HISTORIC LANDMARKS COMMISSION

April 19, 2016

1. CALL TO ORDER
2. ROLL CALL
3. MINUTES
 - a. March 15, 2016
4. PUBLIC HEARINGS
 - a. Exterior Alteration EX15-14 by Daniel Peters to rebuild the exterior stairs and add a two-story deck on the NW corner elevation and change a 1:1 window to multi-light door on the North elevation (2nd floor) of an existing single family dwelling at 726 27th Street in the R-2, Medium Density Residential zone. This item was continued from the March 15, 2016 meeting.

EX15-14 Exterior Alteration EX15-14 by Daniel Peters to rebuild the exterior stairs and add a two-story deck on the NW corner elevation and change a 1:1 window to multi-lite door on the North elevation (2nd floor) of an existing single family dwelling at 726 27th Street in the R-2, Medium Density Residential zone. The application was continued from the February 16, 2016 meeting.

Figure 1: stairs to existing landing, 19' first level porch to stop at corner of bay window, 1x6 tongue and groove decking

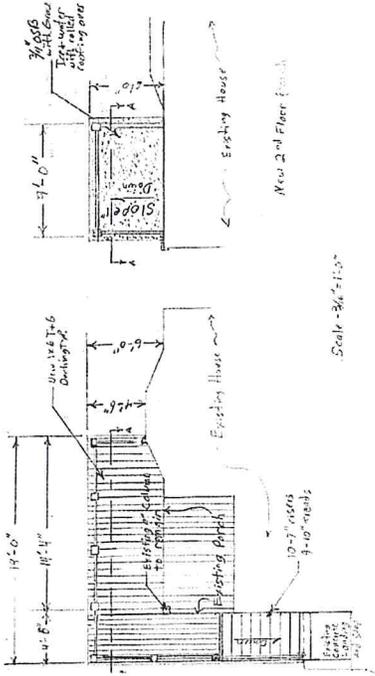
1. The HLC will approve the architectural details with respect to the posts, balustrades, materials and lattice work previously proposed and reviewed in the staff reports.
2. If the bottom of the lower deck aligns with the bottom of the bay window, the deck must stop at the corner of the first outside corner of the bay window.
3. If the bottom of the lower deck does not align with the bottom of the bay window, the deck must extend past the bay window.
4. The second floor deck shall extend out six feet, as proposed.
5. The northeast corner of the deck must be set in eight to ten inches from the corner of the building, set to the west.
6. The newel posts on the east side of the deck must align with existing trim on the corner of the porch.

Figure 2a: Second story porch inset

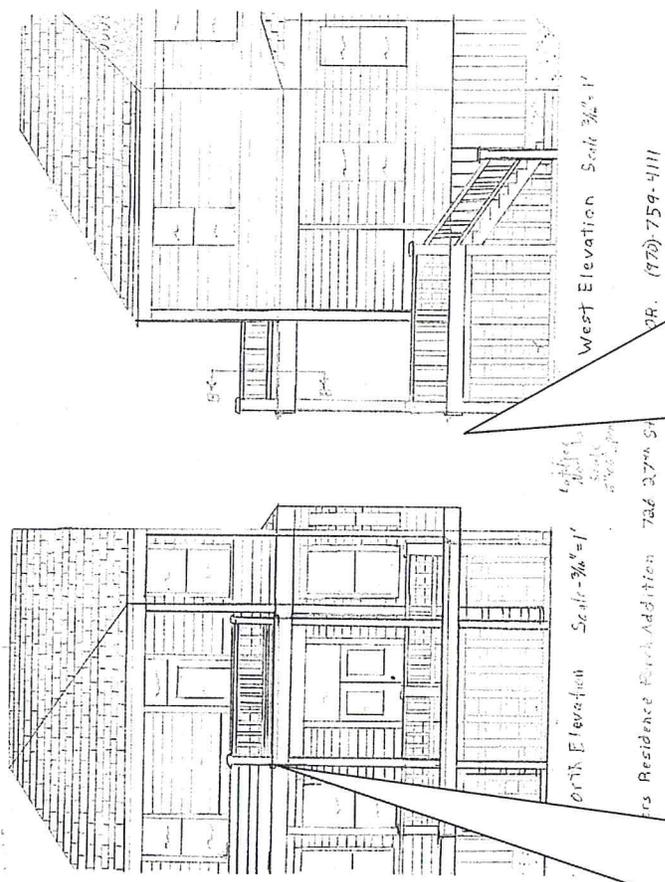
Figure 2b: Lattice work with 6"x6" openings, Balustrades rails to line up on top and lower porches

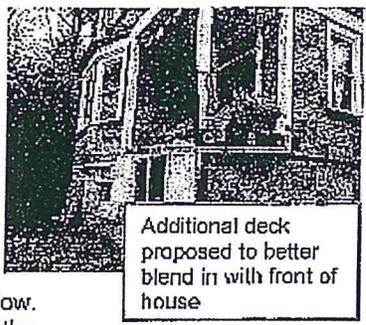
West side porch deck
and railing to be similar to existing porch railing. The railing should be similar to existing railing. The railing should be similar to existing railing.

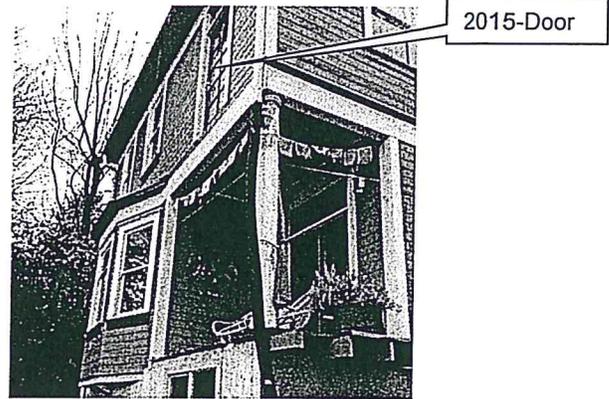
Finding: The applicant has removed a one over one window on the front second floor elevation, and replaced it with a multi-lite door.

The distinguishing characteristics of a Queen Anne style house included recessed porches, but do not include protruding decks. Therefore, removal of the historic window does not meet this criterion. Since the door has already been installed, the applicant should remove the door, and replace to the original one over one window. (Condition 1b)

1b. The applicant shall remove the second story door, and replace with a one over one window.

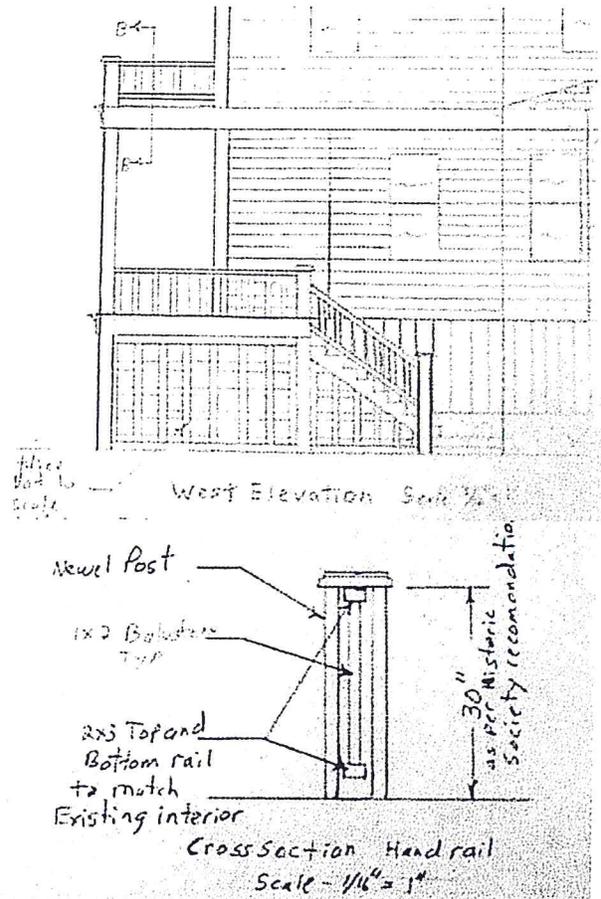
The proposed newel post will mimic the design of post in the photo below, which is an existing newel post from the interior of the house. The landing balustrade has upper and lower rails. Supporting posts shall be incorporated into the porch, and not exposed on the exterior, fascia board, or other cover should hide any construction detailing. (Condition 3a and 3b).

The balustrade on the stairs will also have an upper and lower railing, and should end in a newel post. The upper rail should not extend beyond the newel post. (Condition 2a and 4b). A lattice underneath the stairs will have a 6" by 6" opening, similar to the example in the picture below. This lattice work is proposed to wrap around the front of the house in addition to underneath the staircase. It will be painted to match the house to maintain the stylistic features.

4b. Supporting posts shall be incorporated into the porch, and not exposed on the exterior. A fascia board or other cover shall hide any construction detailing.
